**Notice of Allowability**

10/813,769

### EXAMINER'S AMENDMENT

FIG. 3A

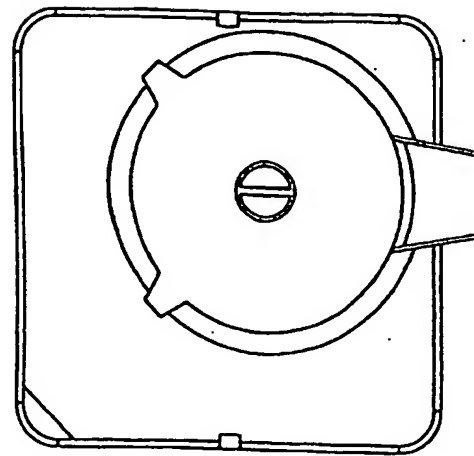
-- PRIOR ART -- has been added in FIGS. 3A, 3B, 4A, 4B, 10 and 10A.

In order to avoid abandonment of the application, applicant must make these above agreed upon drawing changes.
